CITY OF ALBUQUERQUE

Re: Bruckner Truck Sales, Inc., Drainage Report and Grading Plan
Engineer's Stamp dated: 7/19/12 (J09/D021)

**RE: BRUCKNER'S TRUCK SALES,
DRAINAGE REPORT AND GRADING PLAN
ENGINEER'S STAMP DATED: 7/6/12 (J09/DO21)
COMMENT RESPONSE**

INTERIM DRAINAGE
BASIN EXHIBIT

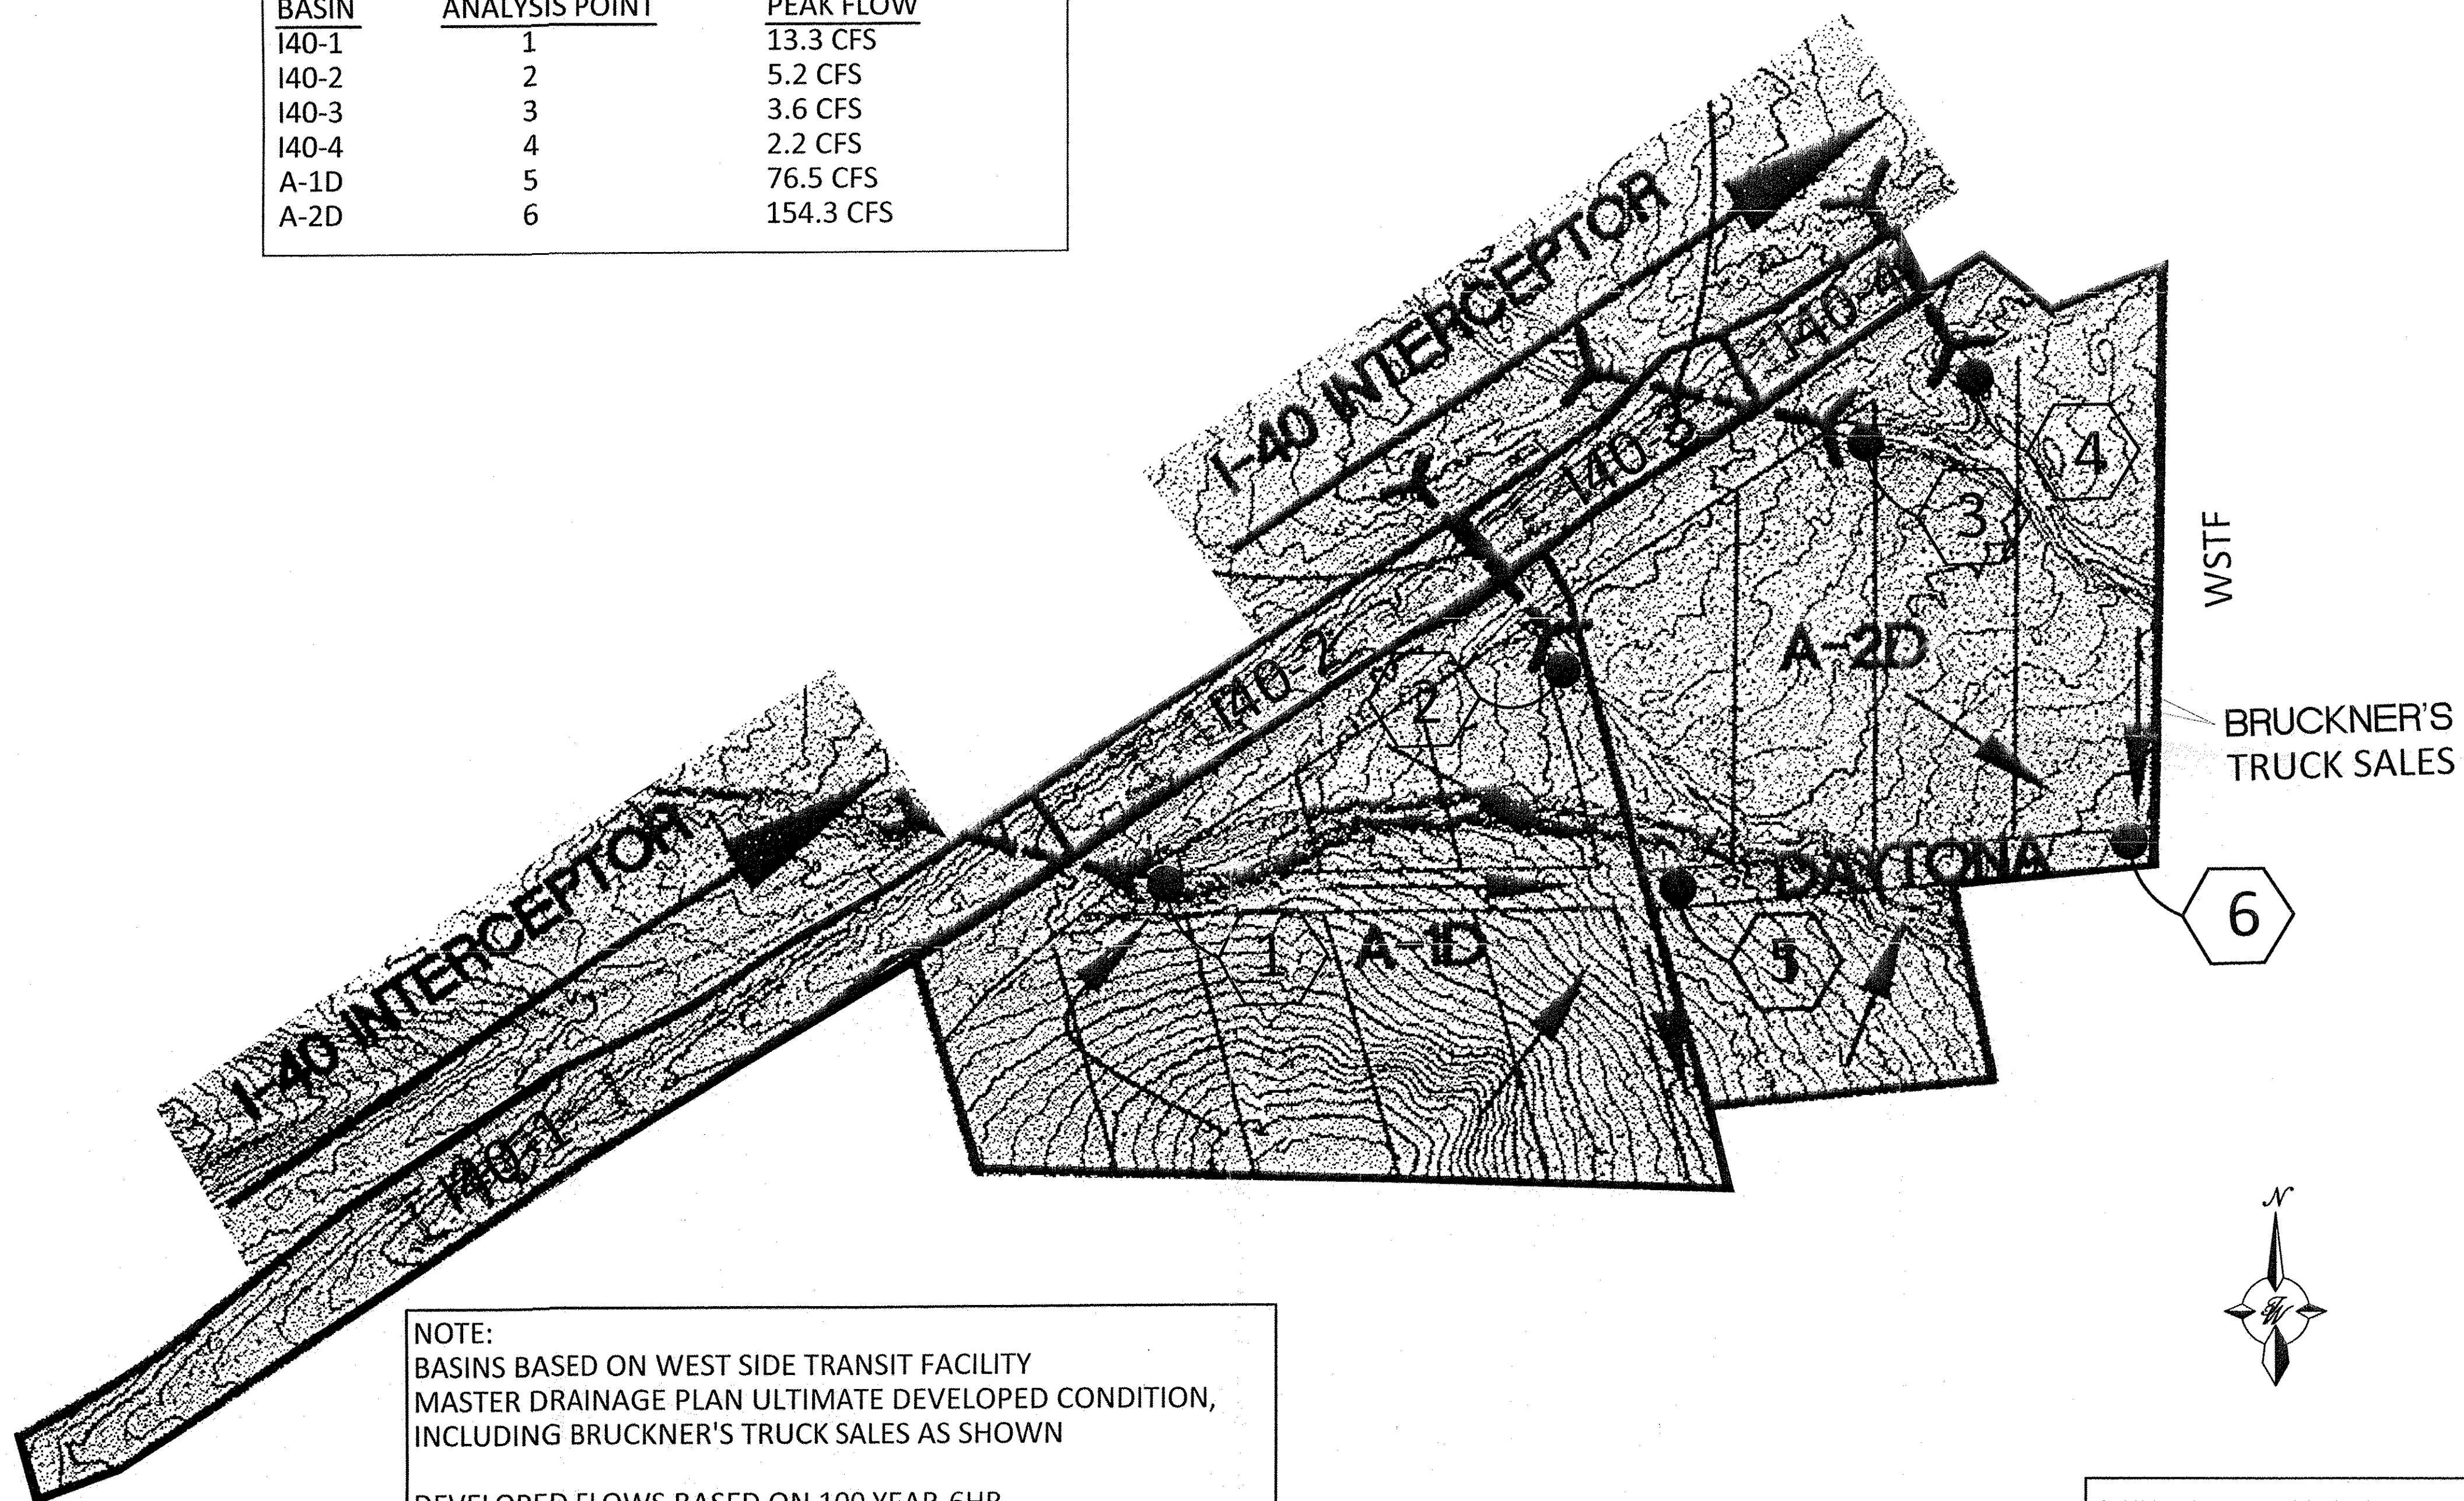
1. Basin maps are required to include contours and the built environment.
All basin maps were updated to include contours, as requested.
2. Land Treatment A is shown in the basin tables for developed areas. Land Treatment A is reserved for soil untouched by human activity that has a slope less than 10%. Update the basin tables and recalculate runoff and volume based on revised land treatment types.
The hydrologic tables were updated to indicate corrected land treatment types and peak volumetric runoff and discharge, as requested.

ENGINEER'S SEAL	BRUCKNERS TRUCK SALES	DRAWN BY BJF
		DATE 7/19/12
		2011073-GRB
RONALD R. BOHANNAN P.E. #7868	GRADING AND DRAINAGE PLAN	SHEET # C2
	 TIERRA WEST, LLC 5571 MIDWAY PARK PLACE NE ALBUQUERQUE, NM 87109 (505) 858-3100 www.tierrawestllc.com	JOB # 2011073

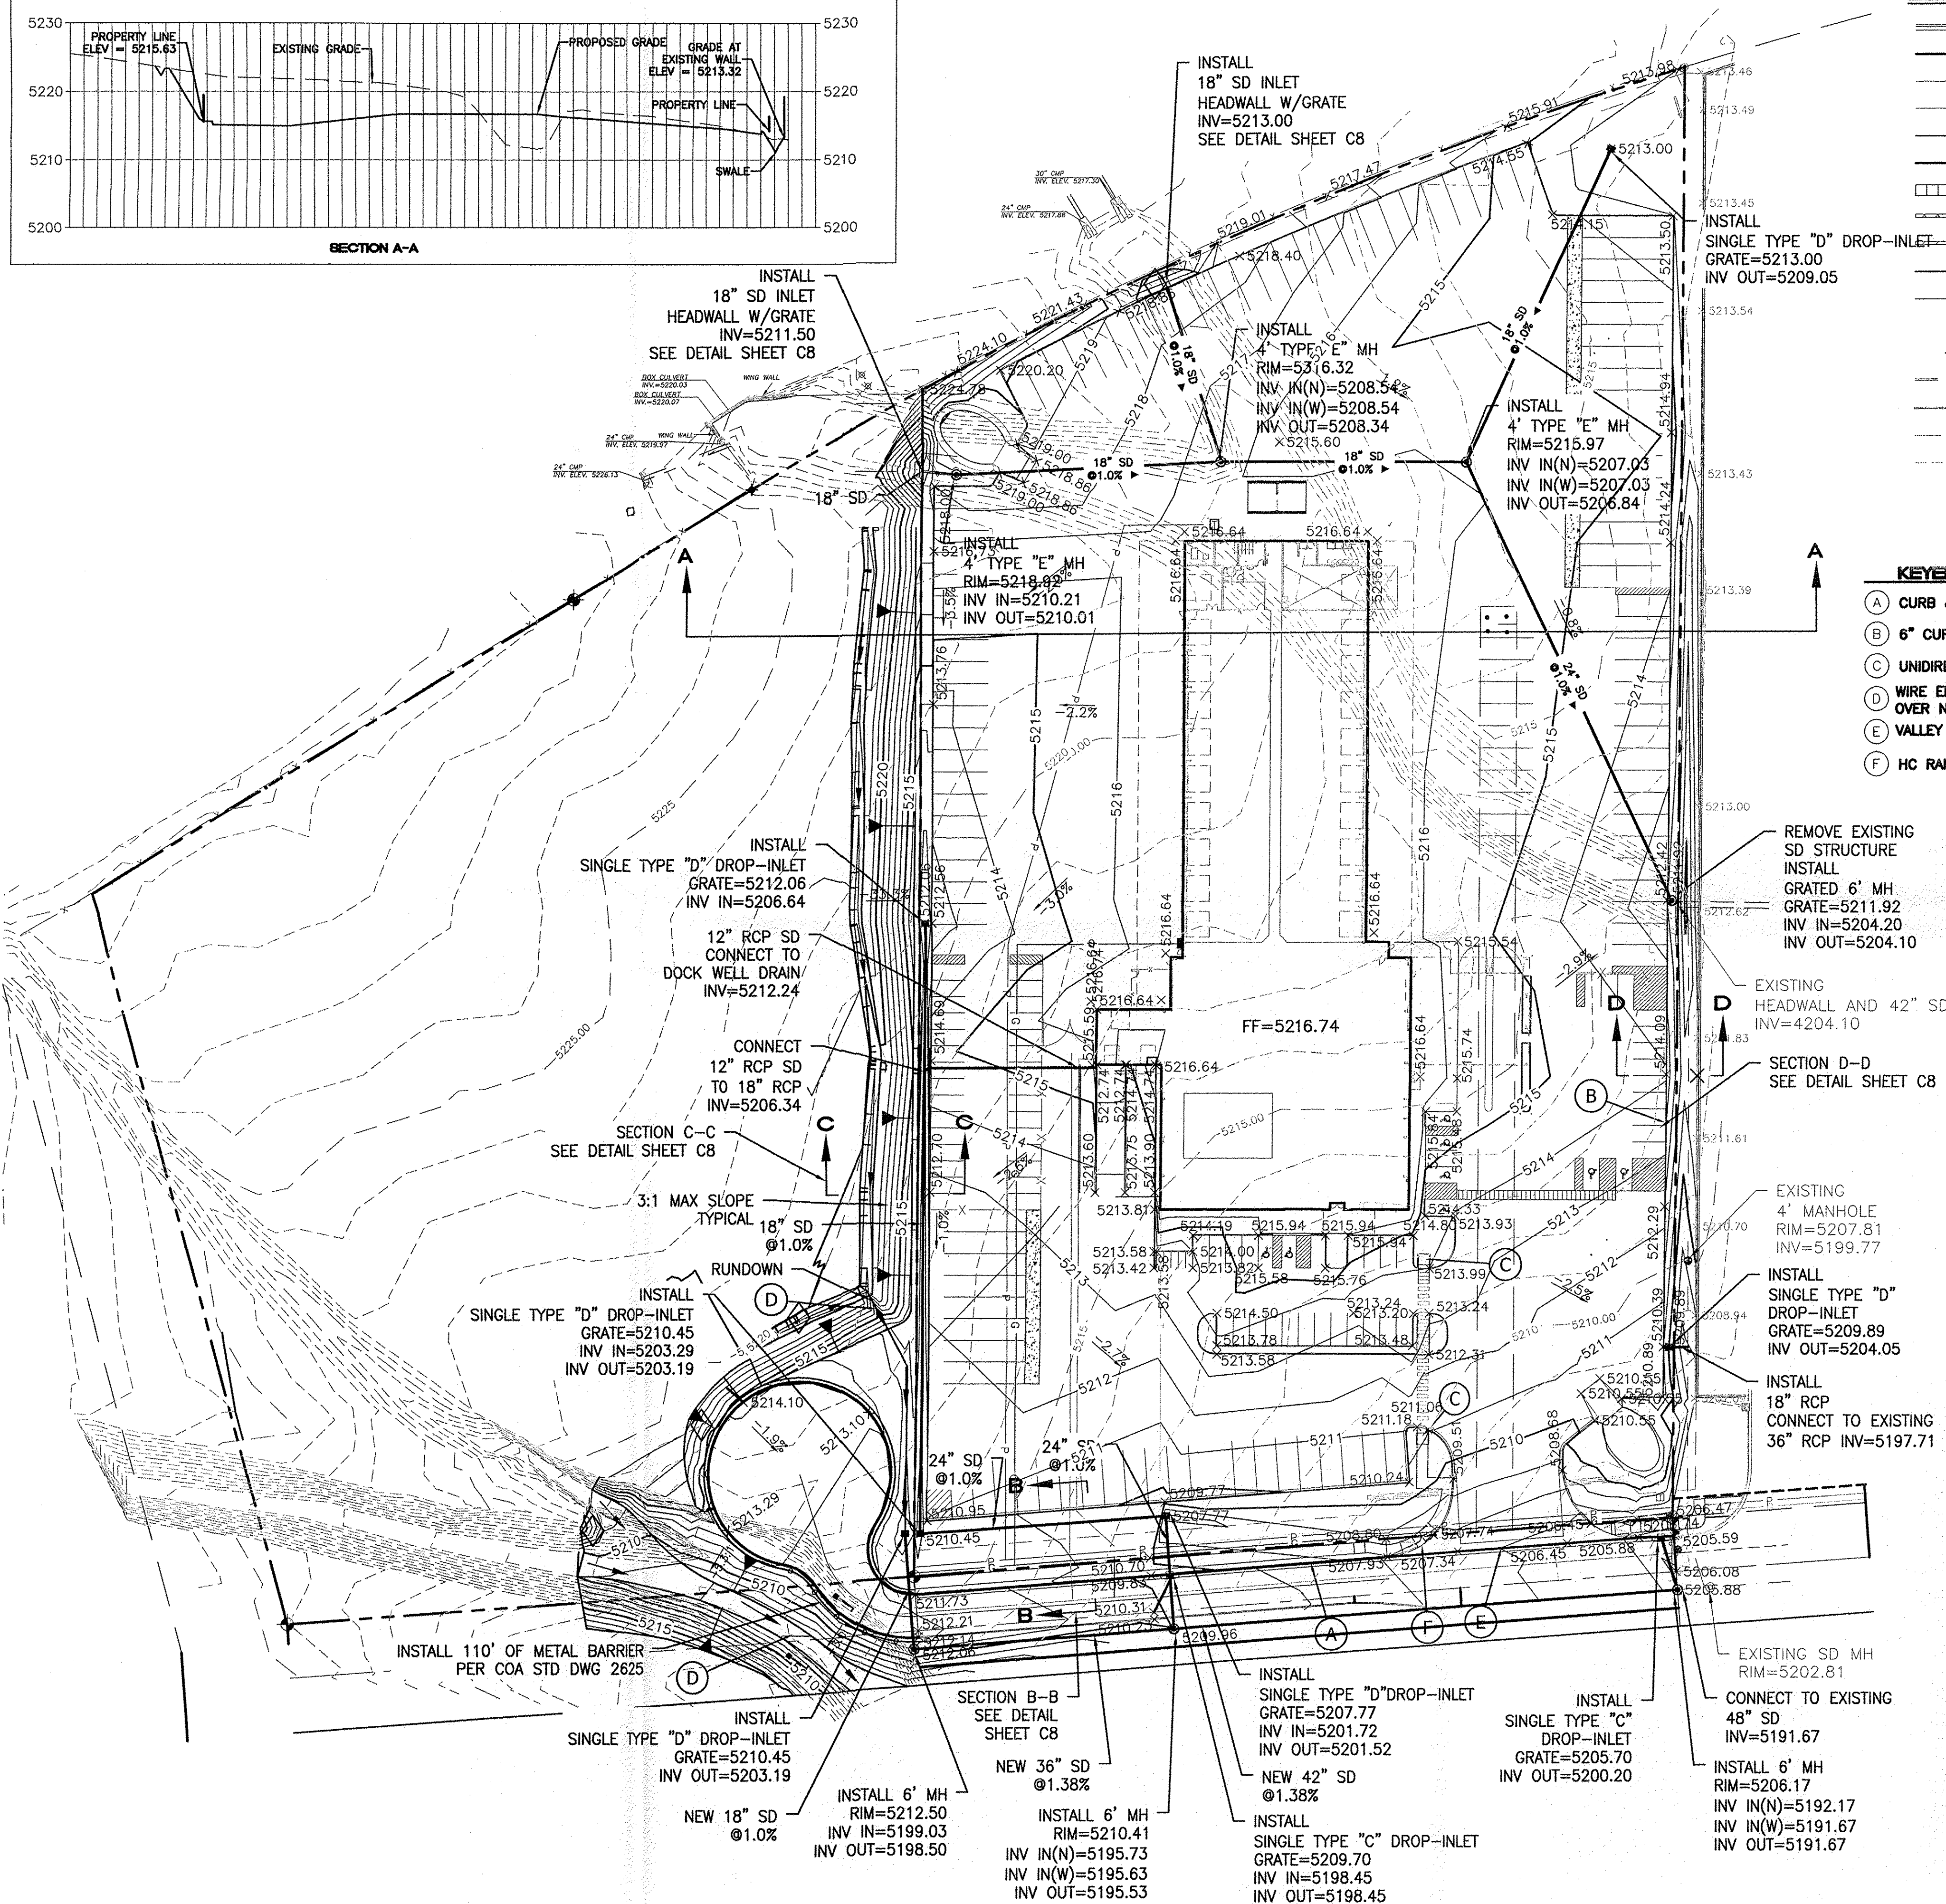
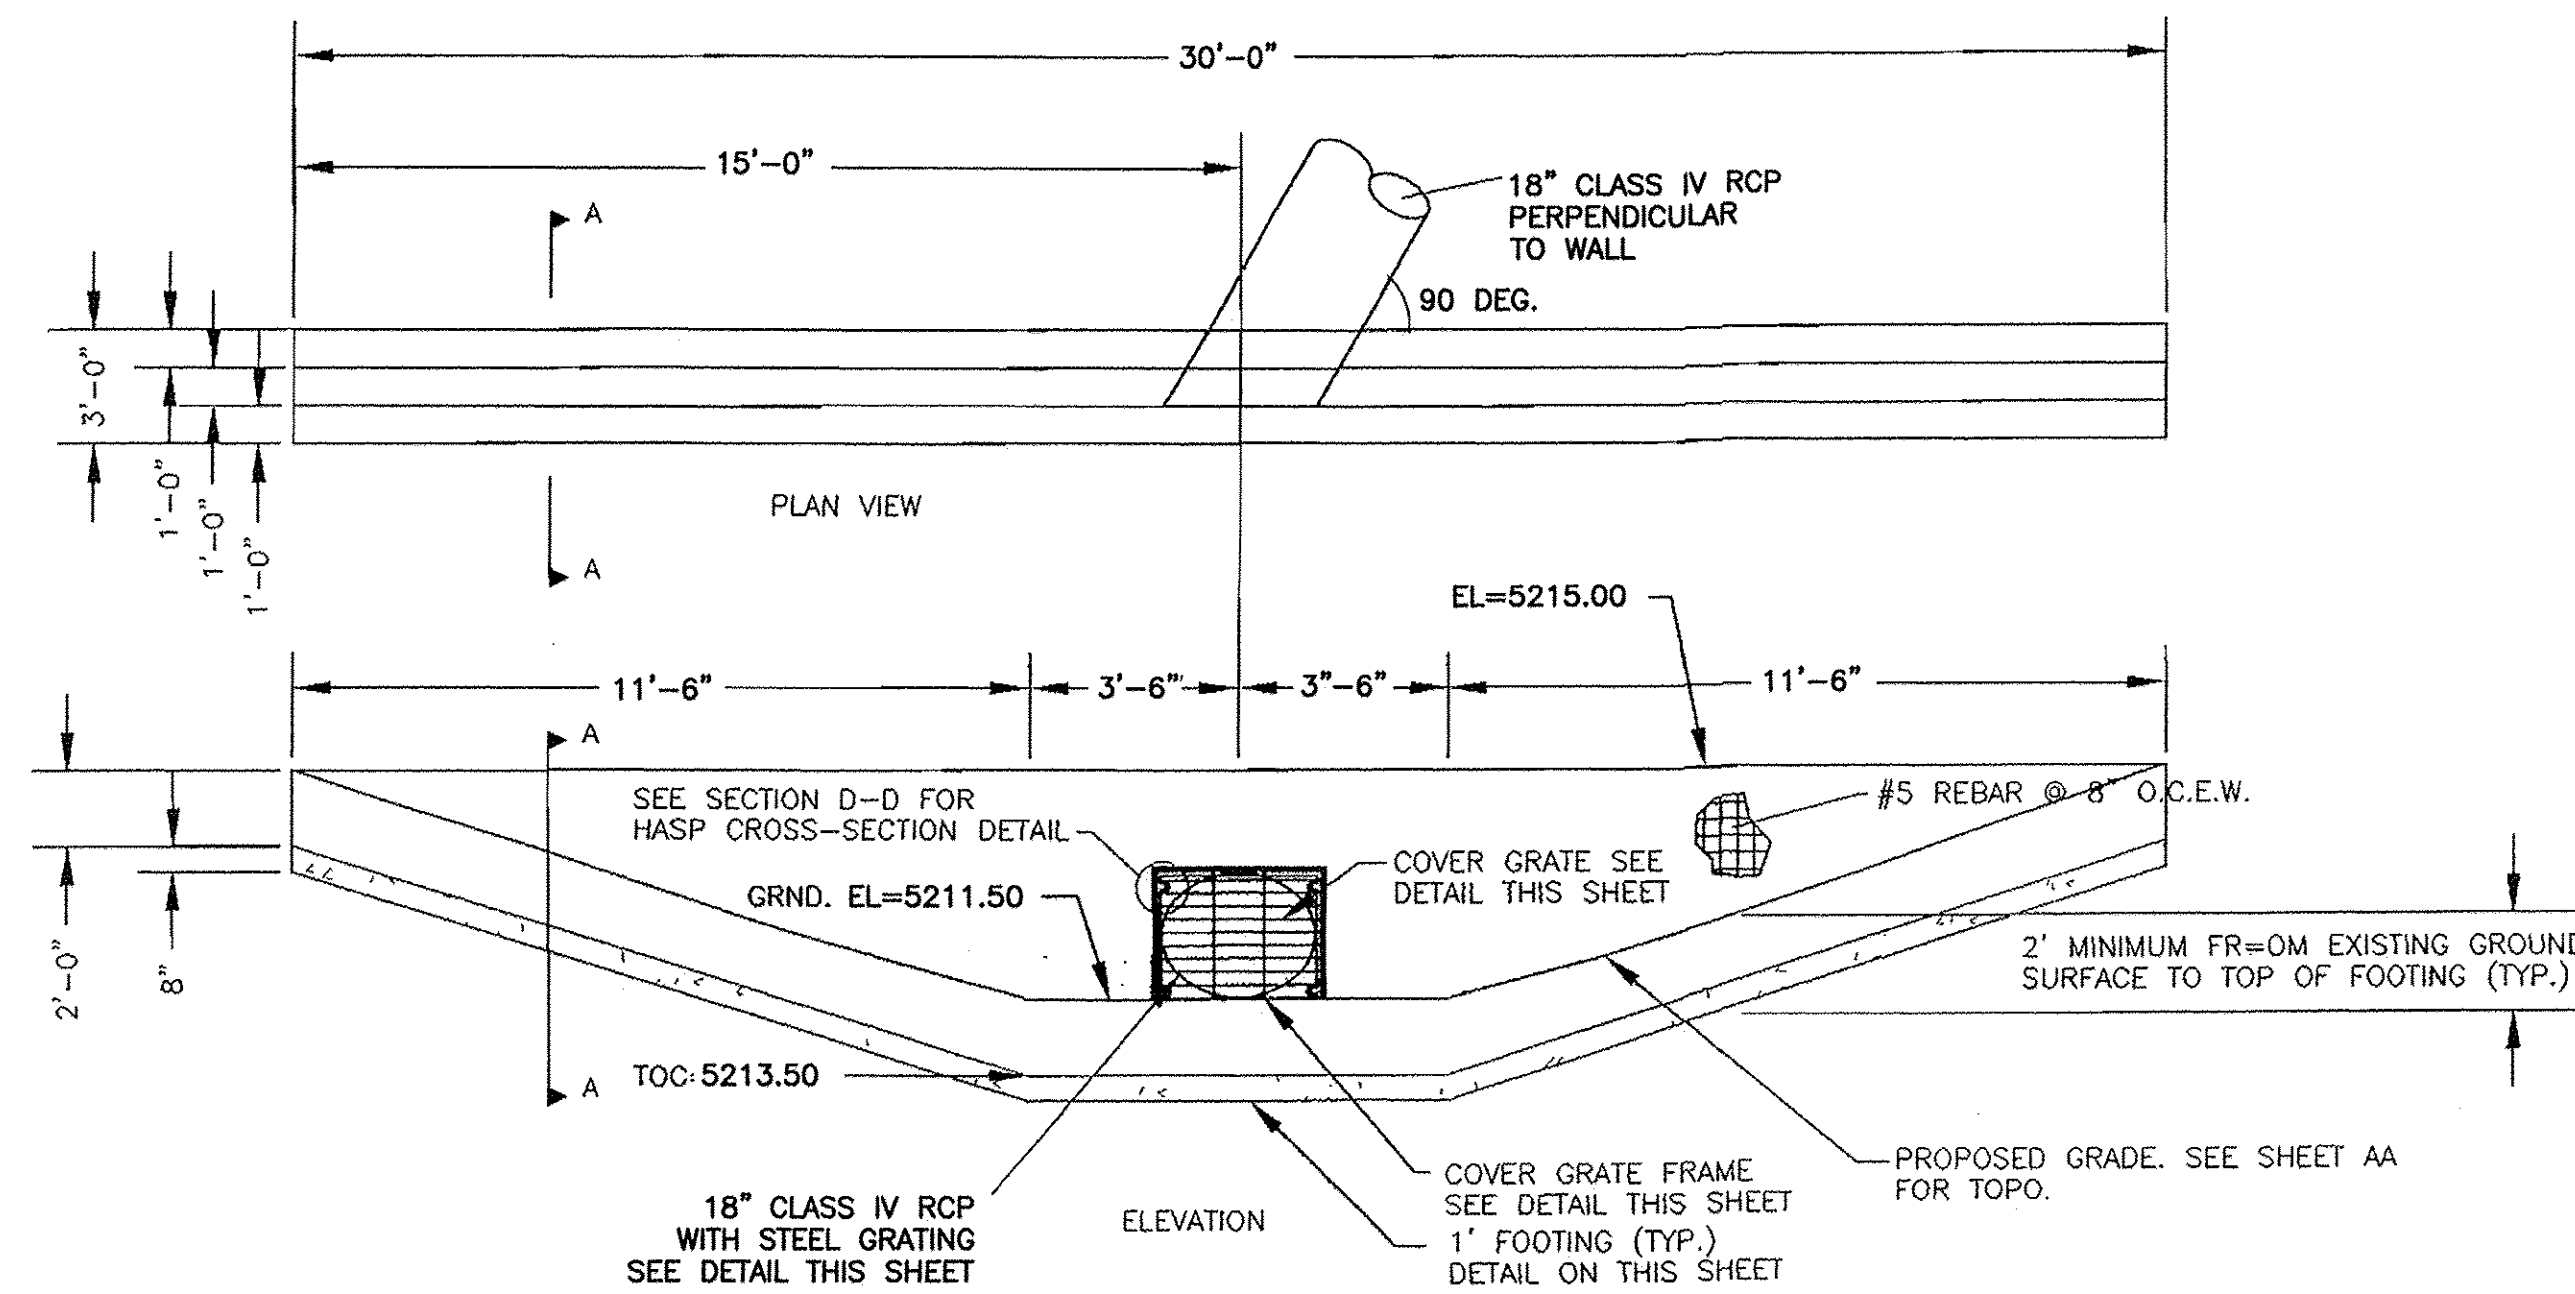
- Include inlet capacity calculations.
- Provide street flow capacity analysis and inlet capacity analysis for Daytona Rd.
- Please provide erosion and scour analysis passed the enclosed riprap for the channel. Would scour wall be required at the end of the riprap?
- What is the status of plugging the 48" storm drain pipe on the north side of the I-40?

7. This plan shows proposed grades in the NMDOT ROW. Grading in the NMDOT ROW should not be required. If it is, NMDOT approval is required.

A previous Grading and Drainage Plan did indicated grading outside of the property, in NMDOT ROW; however this was a surface file grading error. No grading will occur in NMDOT ROW and the Grading and Drainage Plan was updated to reflect this.
